OPTIONAL SERVICE BULLETIN

NO. OSB40-037 & OPTIONAL SERVICE BULLETIN

NO. OSBD4-040

Installation of the maintenance access holes in front seats.

DA4-2511-00-00SB1

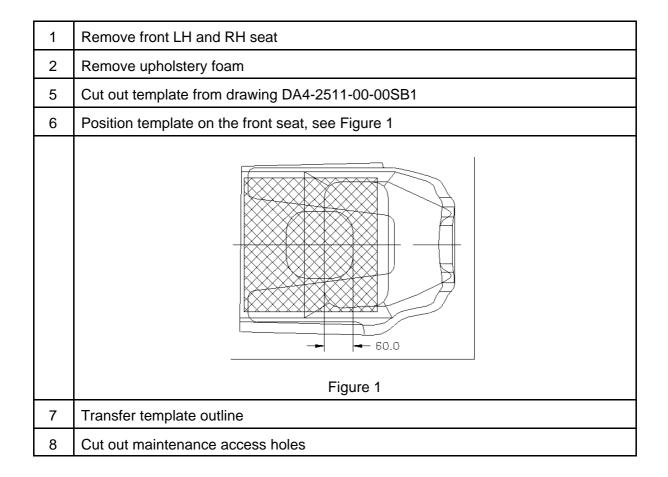
The optional installation of the maintenance access holes in front seats.

9	Position frame kit concisely at the cutout edge, check for regular gap between cut out hole and access cover. See Figure 2	
	Figure 2	
10	Make index marks on frame kit and front seat	
11	For bonding, remove access cover from framework	
12	Remove frame kit peel ply	
13	Check frame kit surface and sand if necessary	
14	Sand bonding area on rear seat	
15	Apply resin L20/H91on bonding area of rear seat	
16	Apply thickened resin on frame kit	
17	Position frame kit using alignment marks and clamp in place	
18	Remove the surplus thickened resin from bearing surface.	
19	Hardening and post curing of bonding in acc. with AMM	
20	Remove tape
